工程指示 / 要求簡箋(E.I.)

工程指示編號：EI / 8600 / 24

工程名稱：將軍澳日出康城 11

工程項目：Glass Cladding 補玻璃 T3 AB 1 件 (高空擲物事件) (地盆執修用)

工程號	J858	類別		物料號	-
地盘	康城11期	制圖	W. E. X	2022-05-12	圖號 J858-GL03
修改	-	採用工廠	✓	地盤	-
日期	-	材料顏色	-	圖紙名稱	玻璃加工圖
		材料	-	復核	-
				批准	-
				數量	-
				單件重量	- (KG)

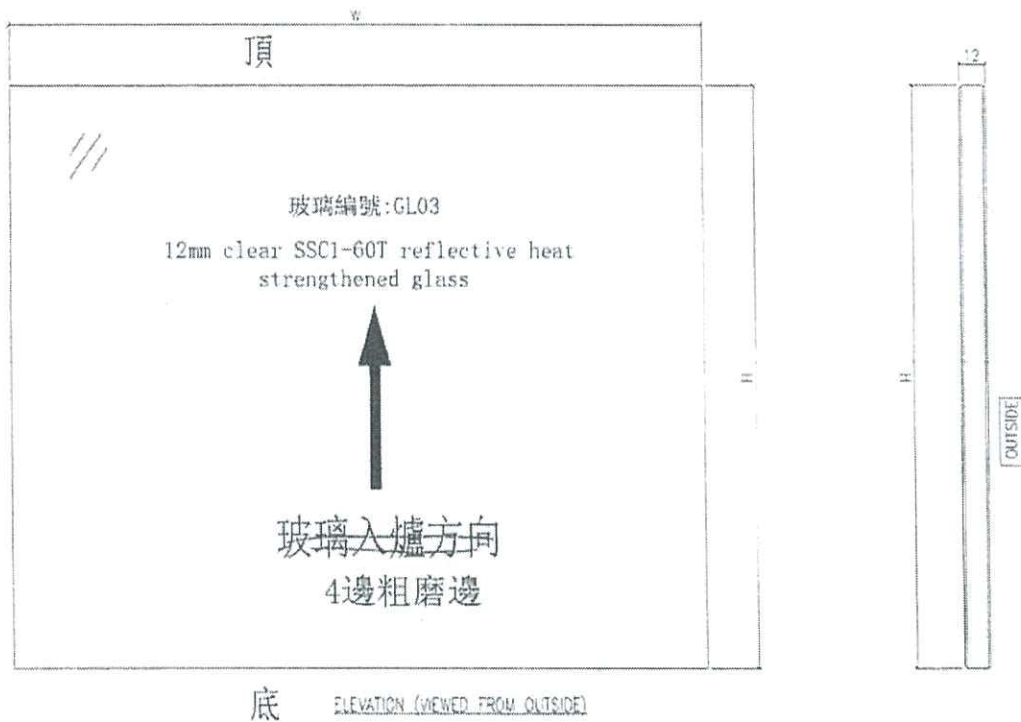
請補此 1 件，

反光片玻璃 (GL03-68) 773Wx 576 H x12mm 厚 送地盆更換。

12mm 反光片，不用熱浸，沒有熱浸標籤

美特鋁質有限公司 MIDI Aluminium Fabricator Ltd.		工程號 J858 地盘 康城11期 图纸名称 GLASS CLADDING 组裝图	類別 制圖 W. C. M 復核 - 批准 -	物料號 - 2022-06-21 圖號 GC-12 數量 35 單幅重量 - (KG)
修改 1 日期 04/05	採用工廠 ✓ 材料颜色 -	地盤 - 材料 -

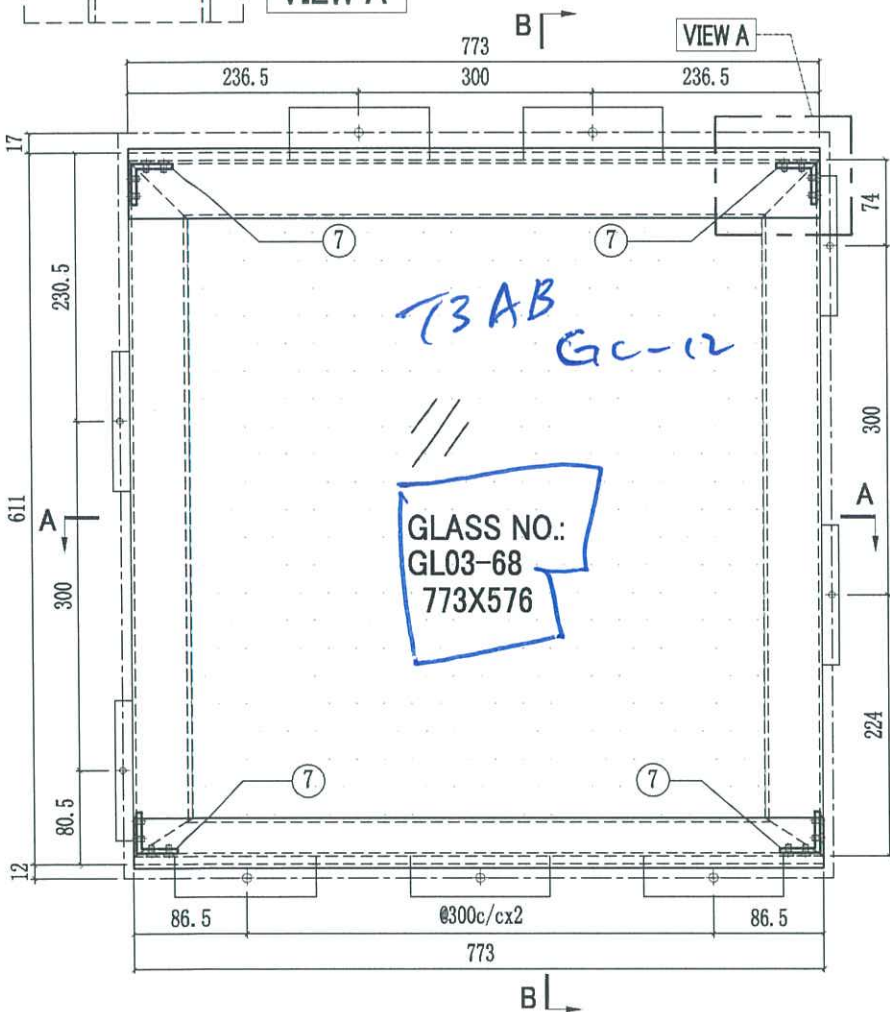
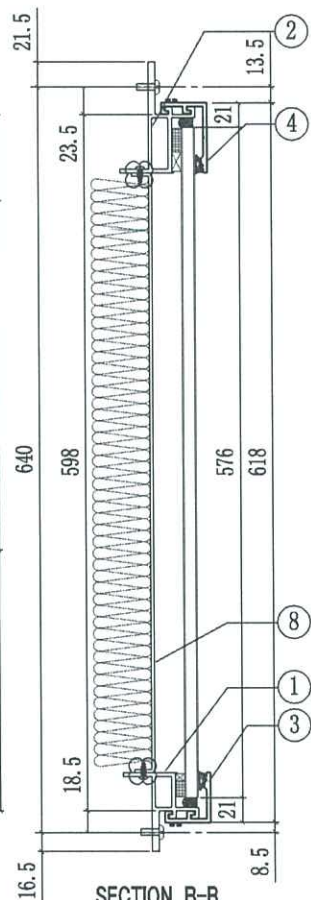
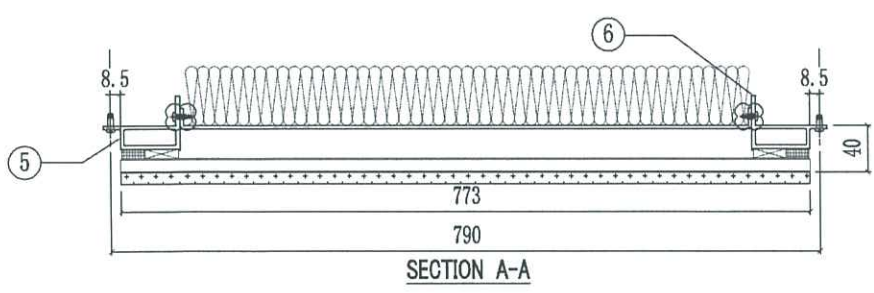
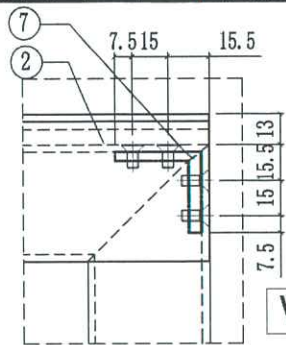
擊中玻璃，導致玻璃損壞，Glass Cladding 編號 T3AB-GC-12，附信 MC43122。

此款設計，更換玻璃比起換整個九字料較易。

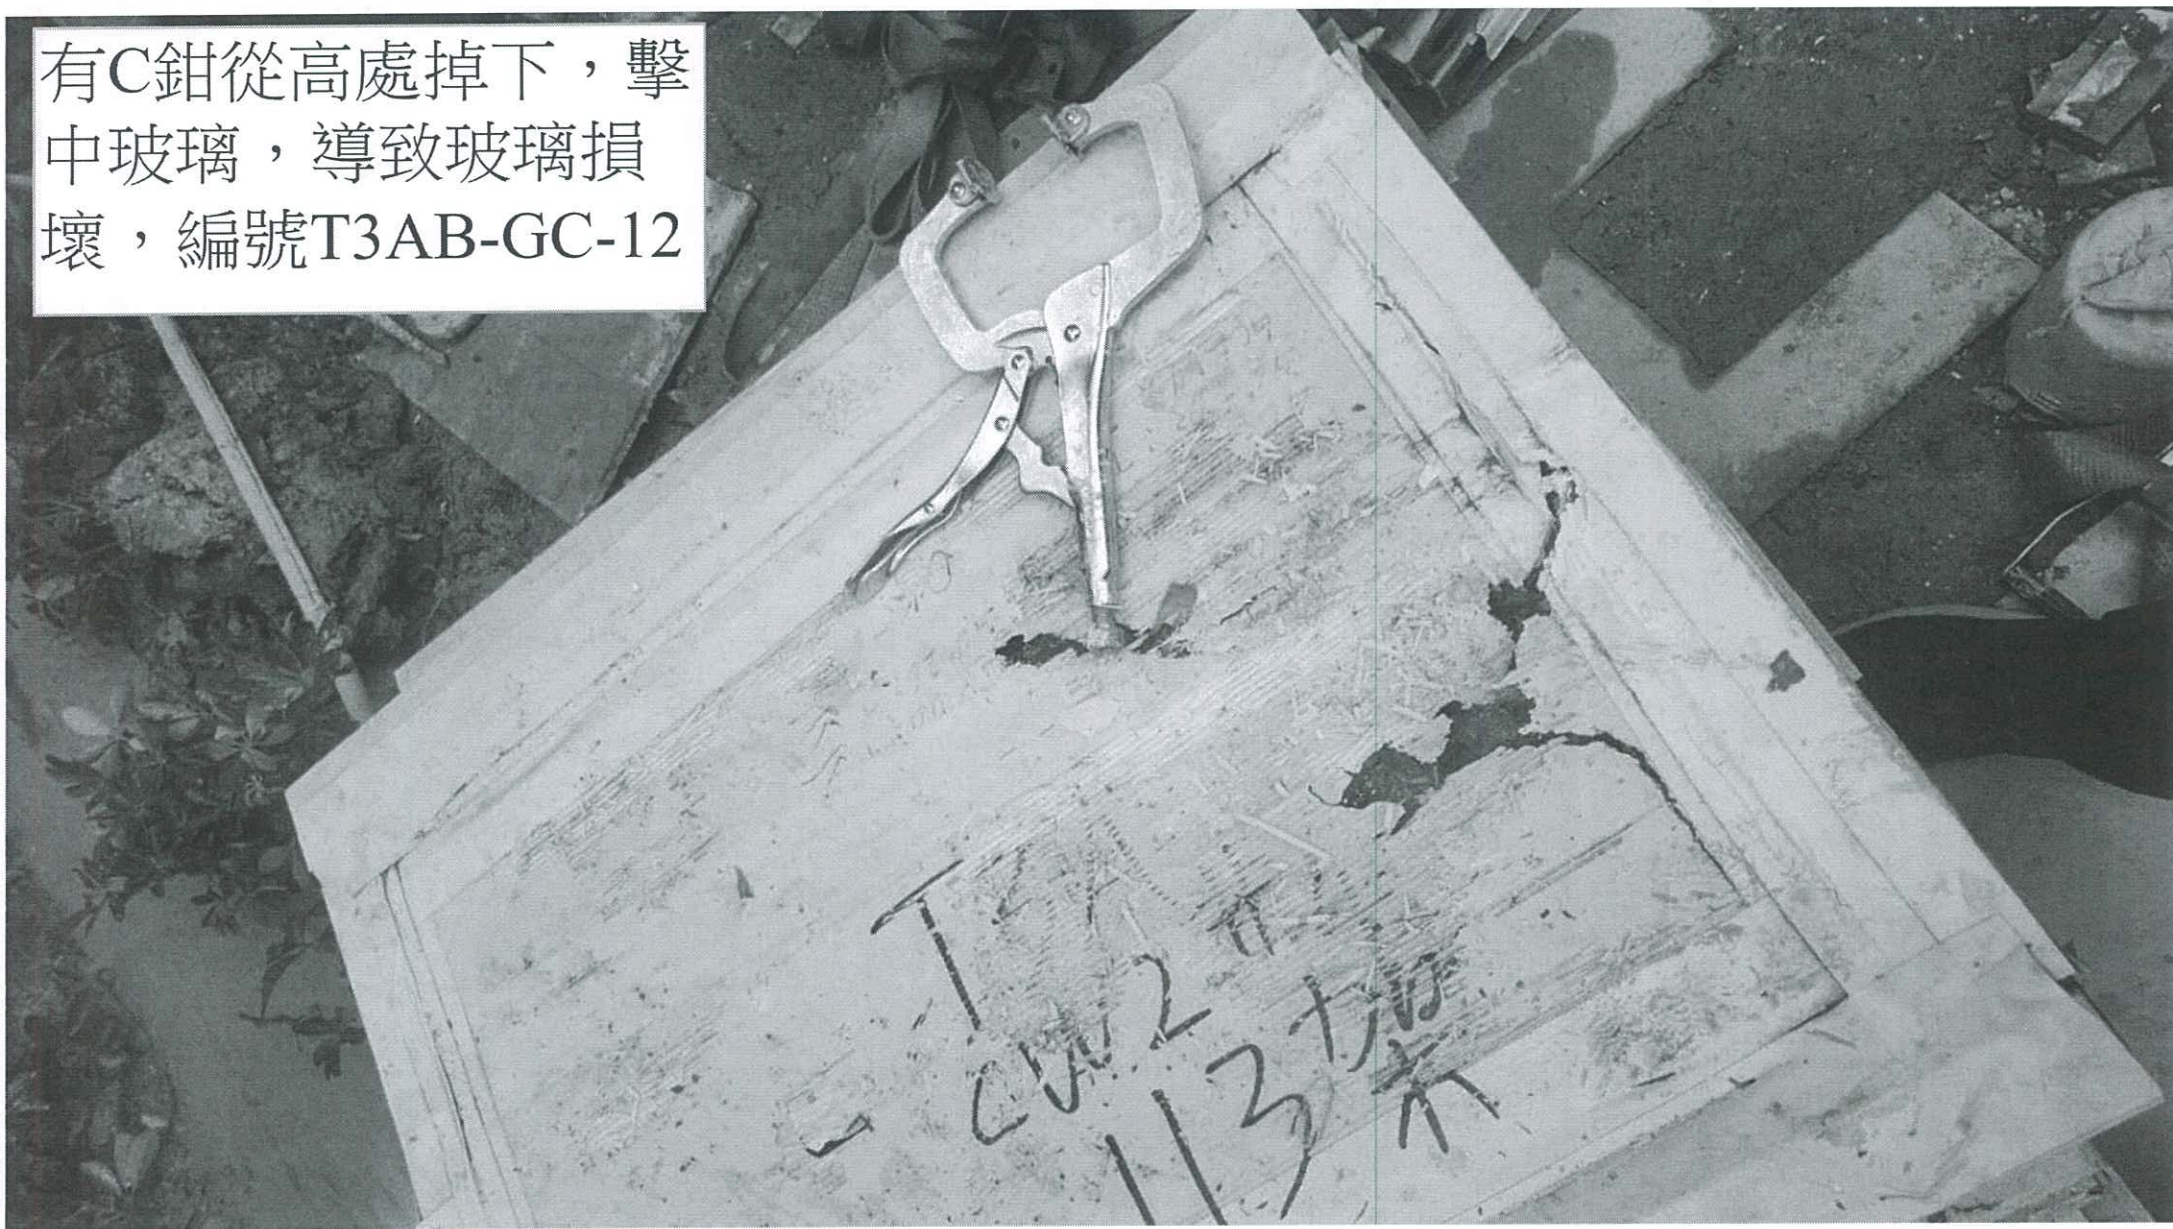
有C鉗從高處掉下，擊
中玻璃，導致玻璃損
壞，編號T3AB-GC-12

圖號 GC-12 #4

位置 T3A-CW2

TITLE : TYPICAL FLOOR PLAN AT TOWER 3

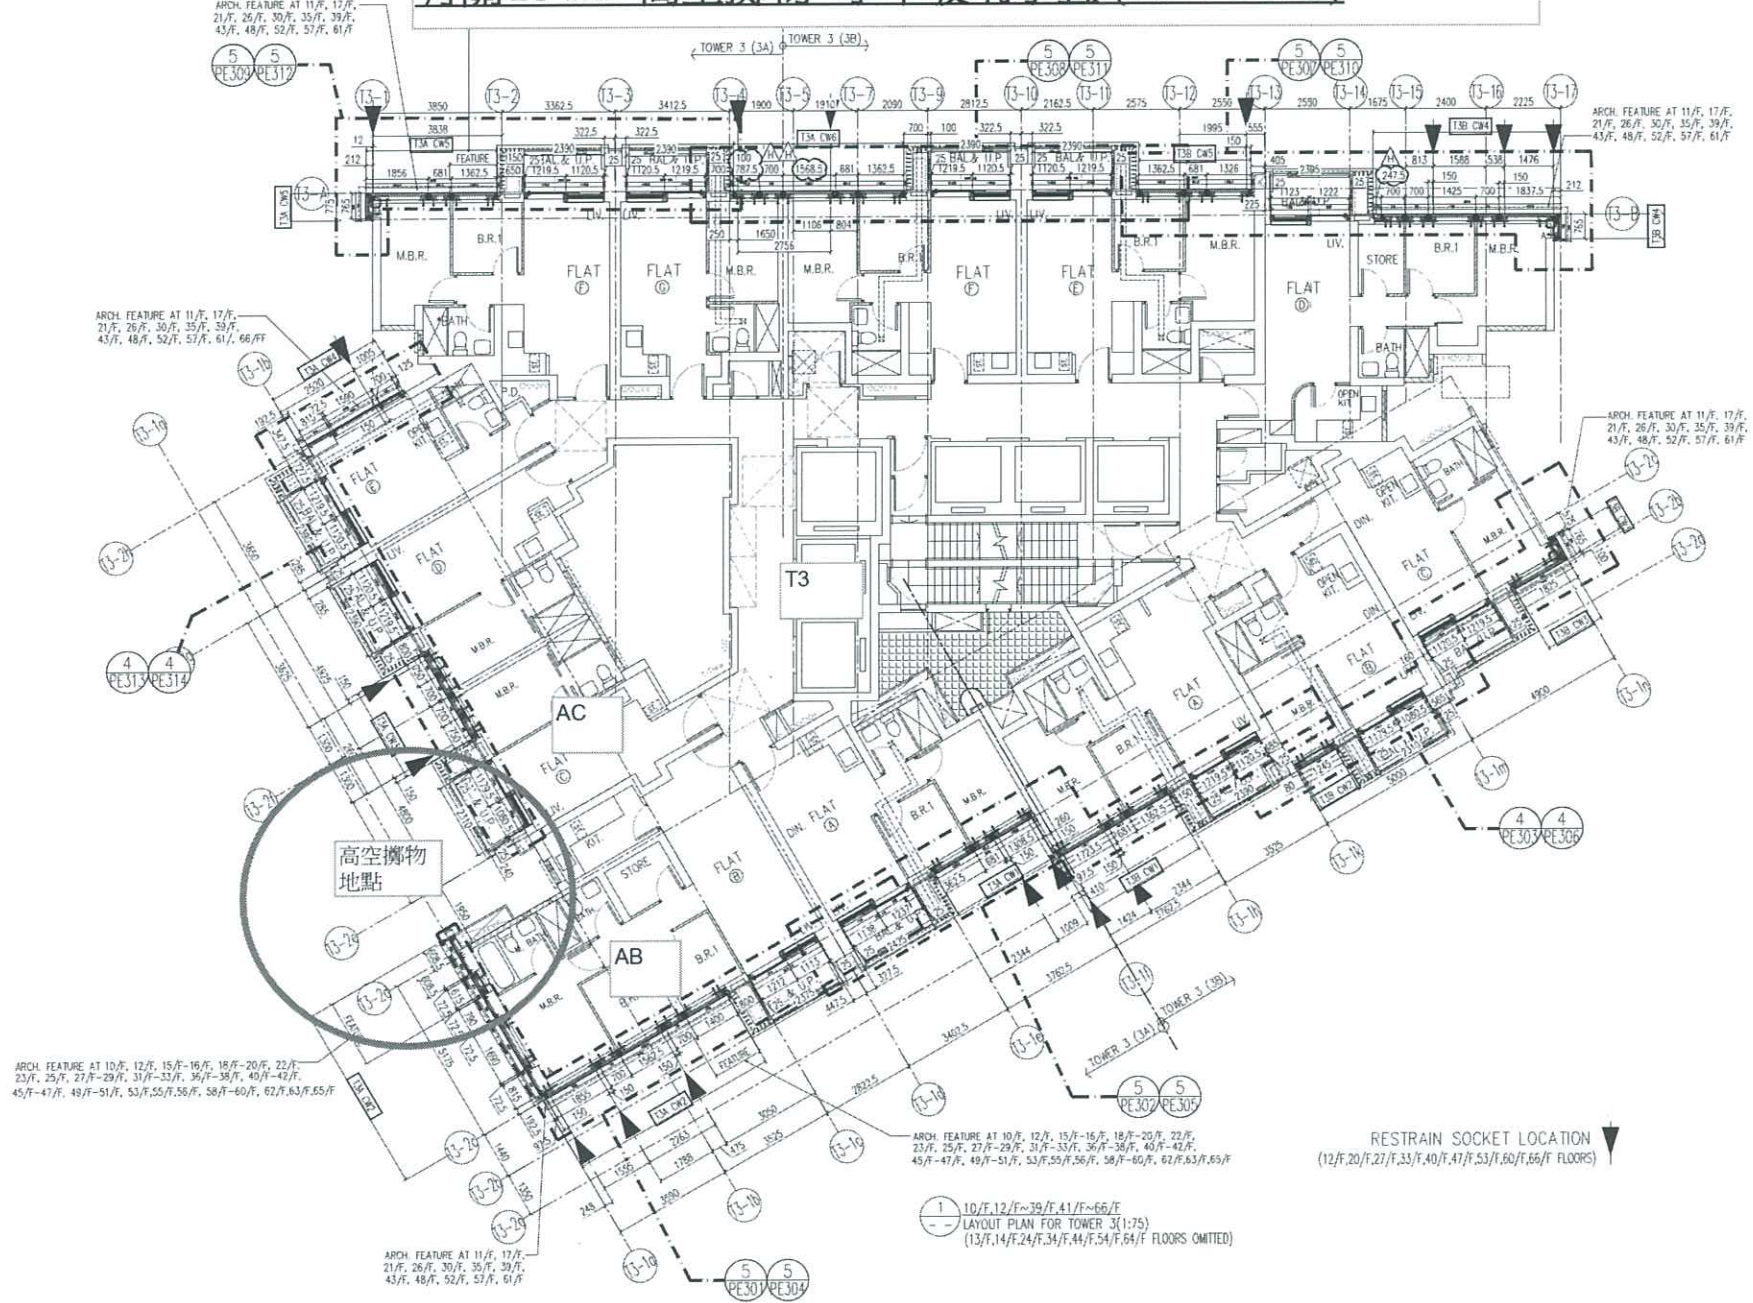
高空擲物地點
